1 LOTS 7212, 7213, 7214 - FIRST FLOOR - PARTITION PLAN  
1:150

**ISSUED FOR CONSTRUCTION**

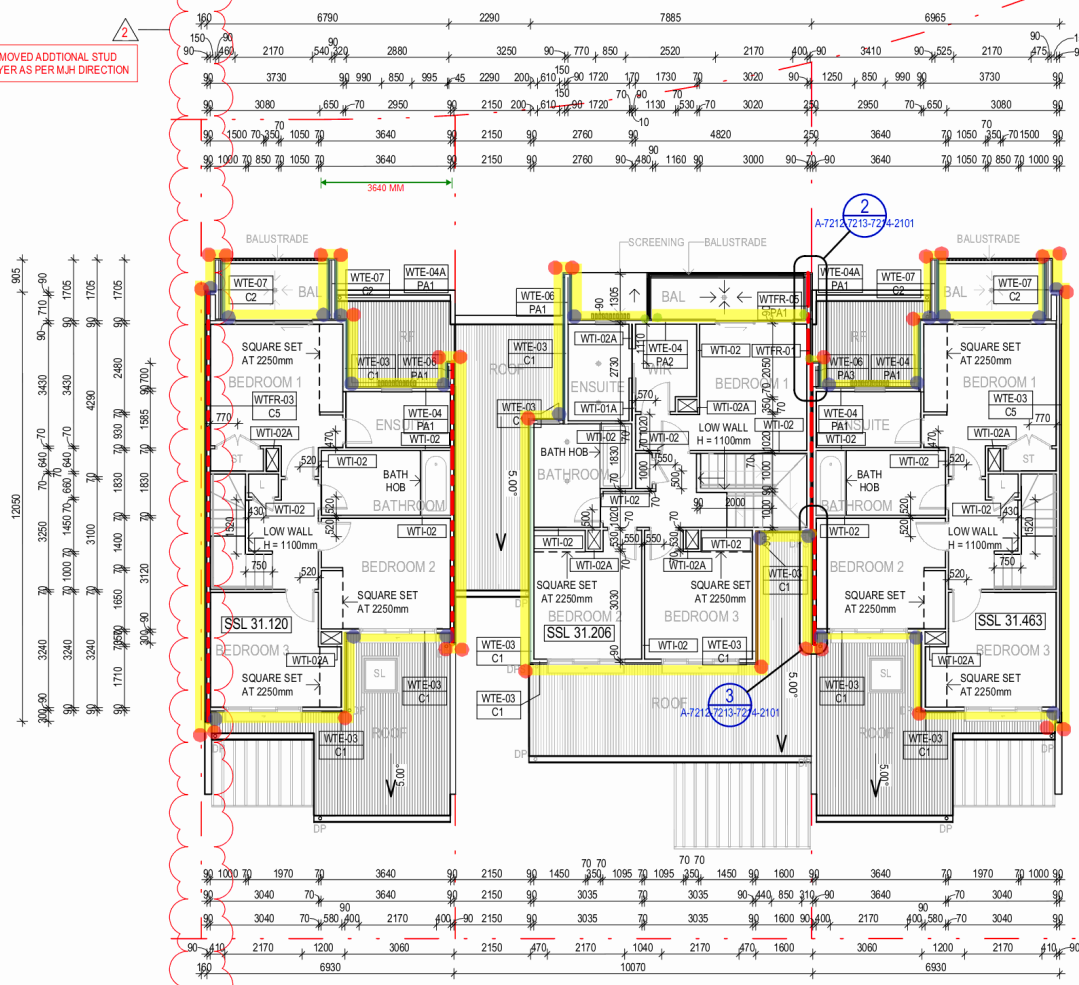
REMOVED ADDITIONAL STUD LAYERS PER MJH DIRECTION
